## MEMORANDUM

RE: Prefiling Conference - Amendment to a Special Use for Carson's Restaurant at 200 Waukegan Road

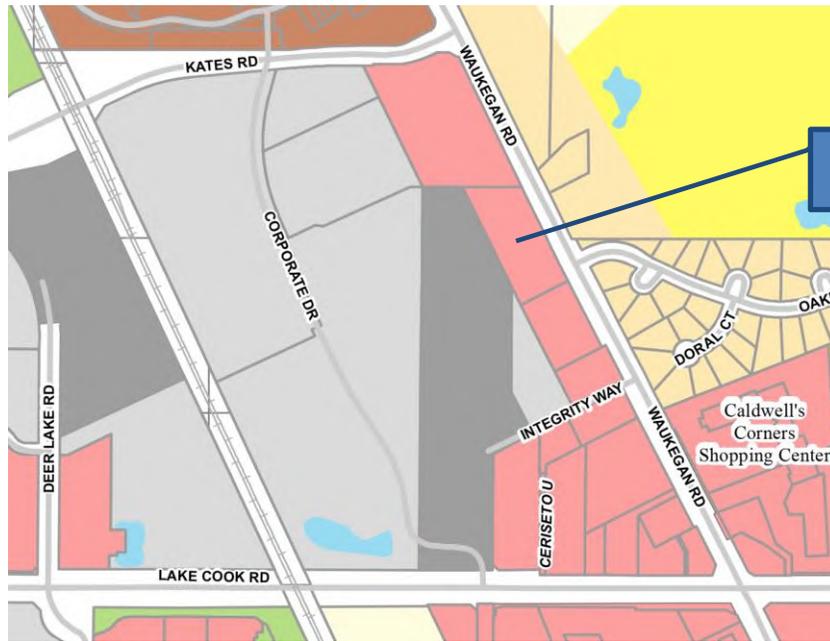
Any new rooftop units to be installed or the replacement of existing rooftop units, need to be screened from public view, or located to not be visible from a public way. New mechanical equipment is noted on the Roof Plan. According to the Architect, the new HVAC units will be screened from view by the new parapet wall.
